ANIMO

ComBi-Line NG Software versions

Date: Oktober 2024

Combi-Line NG software V1.06.01 (release date 14 Oktober 2024)

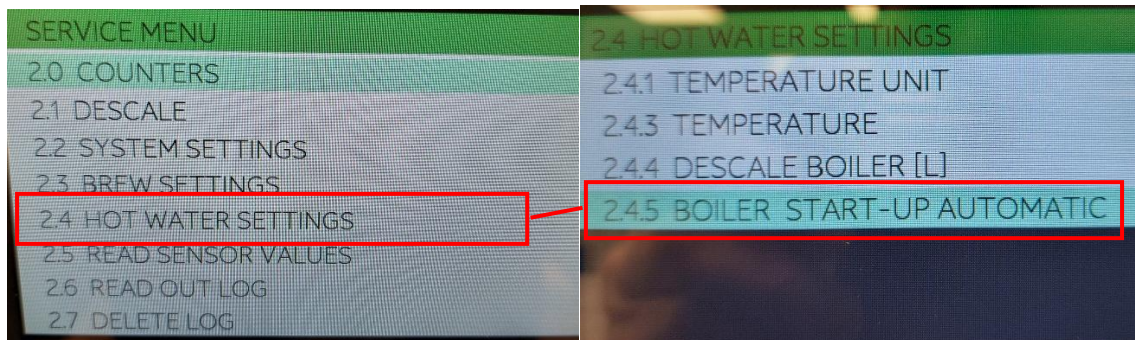
Model CB40 only:

- the "maximum coffee heating time" has been changed to 30 min, because of Error 206.

– **HEATING PRIORITY** (Default = ON)

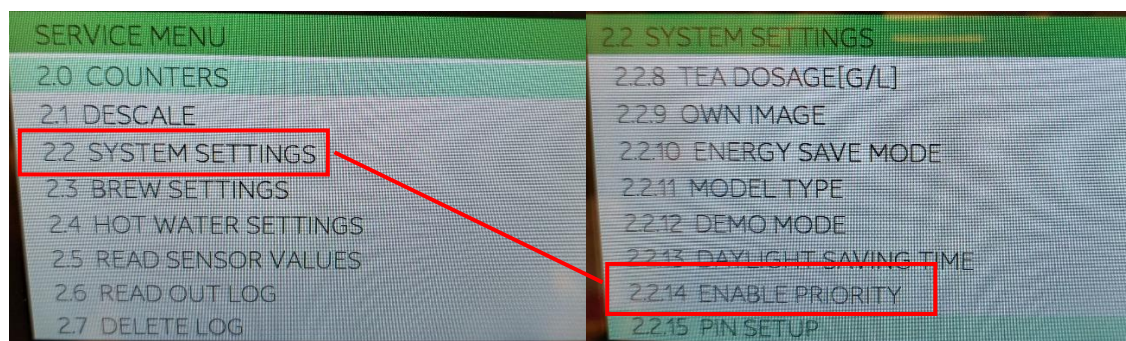
[Service menu / 2.2 System settings / 2.2.14 Enable priority]

- ON = Flow heater has priority above Hot water boiler heater (low Amps)
- OFF = Flow heater & Hot water boiler heat together (Attention: High Amps, check cable and plug spec's)

– **PIN CODE** (Default = OFF)

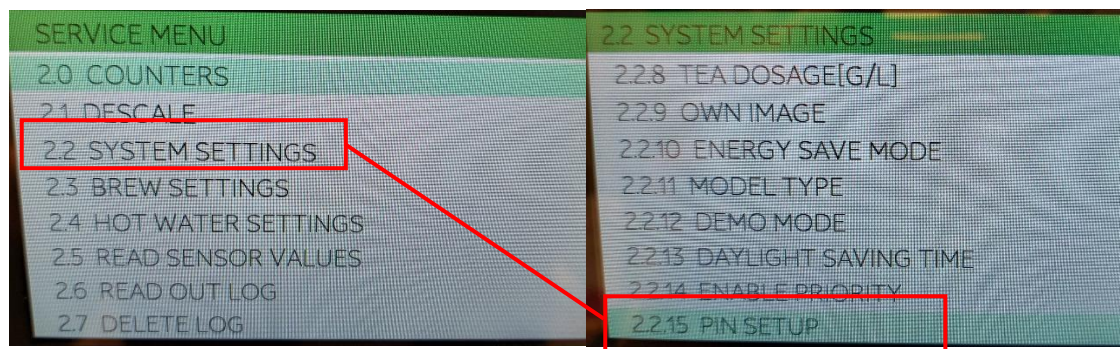
Control panel with active PIN will be protected after 30 seconds with PIN code to block the control panel.

[Service menu / System settings / 2.2.15 PIN setup]

- OFF = no PIN
- ON = PIN [1 1 1 1 1] PIN can be changed
- PIN lost?; Change PIN in Operator menu.
